# SERVICE BULLETIN

No. 464A

Piper Aircraft Corporation

Subject: Inspection of Stabilator Torque Tube Bearing Block Attachment Fitting Rivets.

VIEW A-A: CORRECT RIVET ALIGNMENT

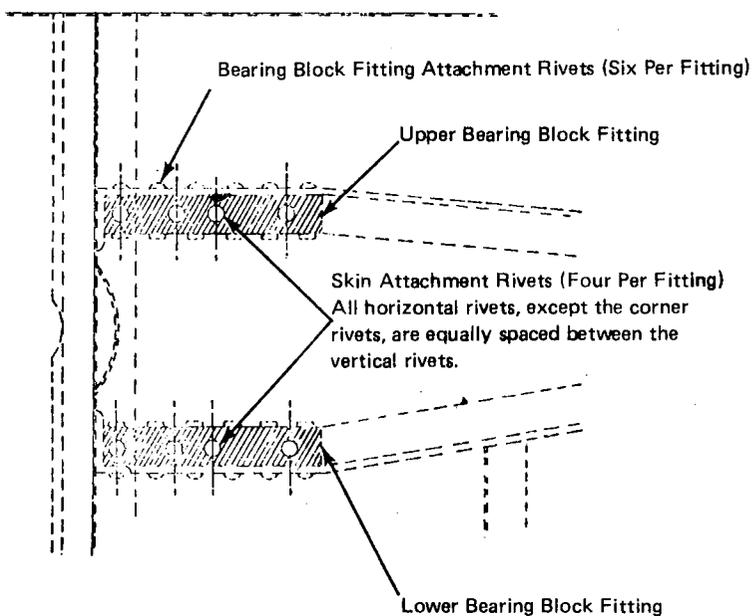
Stabilator Bearing Block Attachment Fitting Rivets (see sketch for an illustration of this condition).

VIEW A-A: RIVET ALIGNMENT which may have resulted in rivet penetration:

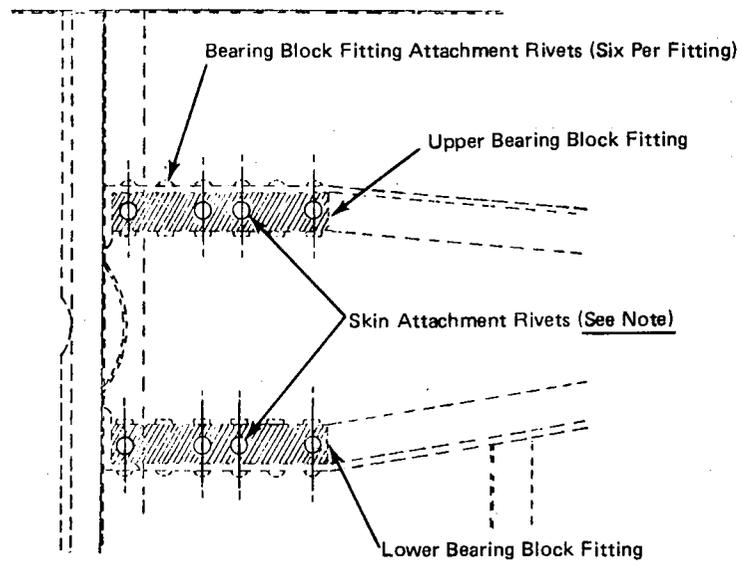
In some instances rivet alignment may be detected during the inspection referred to in Instructions, below, and on the attached sketch/instructions sheet. However, closer inspection may reveal that, although rivet alignment may exist, rivet penetration may not have occurred--in which case, no further action is required.

**NOTE:** All horizontal rivets, except the corner rivets, are incorrectly installed in this view as they are aligned with the vertical rivets. If more than two rivet alignments are evident in each fitting, it will be necessary to install Kit 760 835.
